SUBJECT: COMANCHE PEAK NUCLEAR POWER PLANT, UNITS 3 AND 4
DOCKET NUMBERS 52-034 AND 52-035
COMBINED LICENSE APPLICATION PART 10 REVISION 3, UPDATE TRACKING
REPORT REVISION 1

**Comanche Peak Nuclear Power Plant, Units 3 & 4
COL Application**

**ITAAC and Proposed License Conditions
Revision 3**

Update Tracking Report

**Figure A.3-1 (Sheet 1 of 2) General Arrangement Plan of UHSRS, ESWPT, and PSFSV
Identifying Internal Flood Barriers**

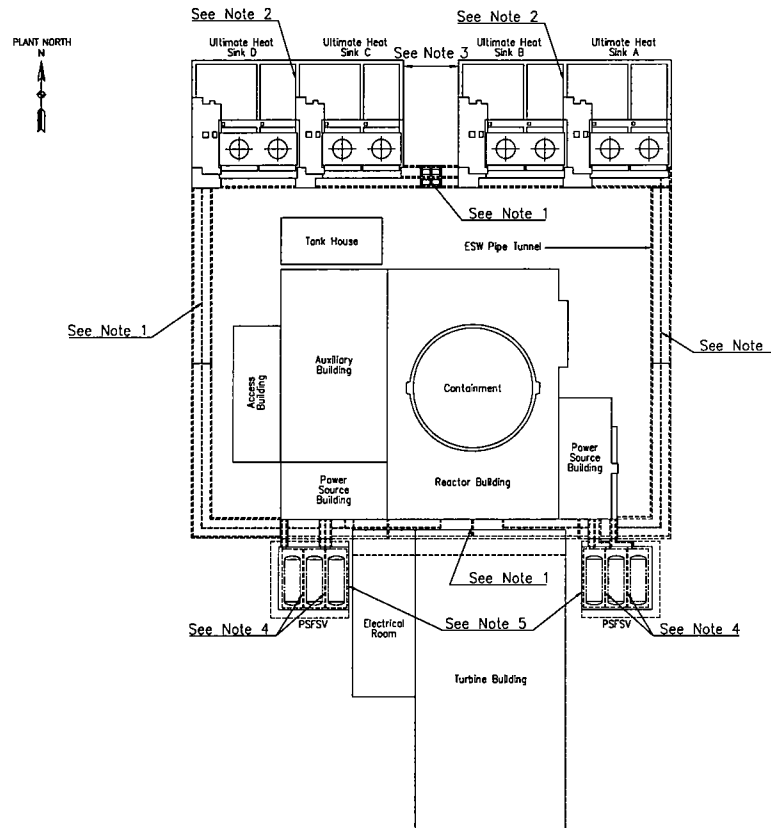
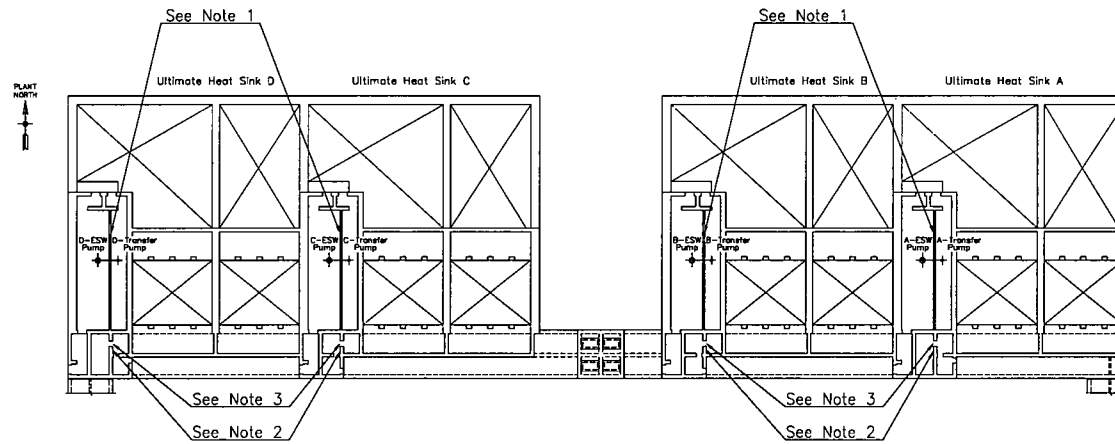
Change ID No.	Section	ITAAC Rev.3 Page *	Reason for change	Change Summary	Rev. of T/R
CTS-01511	Appendix A.3 Table A.3-1	35, 36, 37 [38]	To reflect updates on the Technical Report MUAP-10006(Rev3)	The wording in the title of the ITAAC Table A.3-1 is changed replacing "USHRS, ESPWT and PSFSV" with "Plant specific structures".	1
CTS-01512	Appendix A3 Table A3-2 (sheet 1, 2, 3 [4])	38, 39 and 40 [41, 42]	To reflect changes in Plot Plan and AIA.	Floor elevations and wall thicknesses revised.	1
CTS-01512	Appendix A.3 Figure A.3-1 [Sheet 1 and 2 of 2]	41 [43, 44]	To reflect changes in Plot plan	Overall General Arrangement plan replaced with the updated version; and minor editorial correction.	1
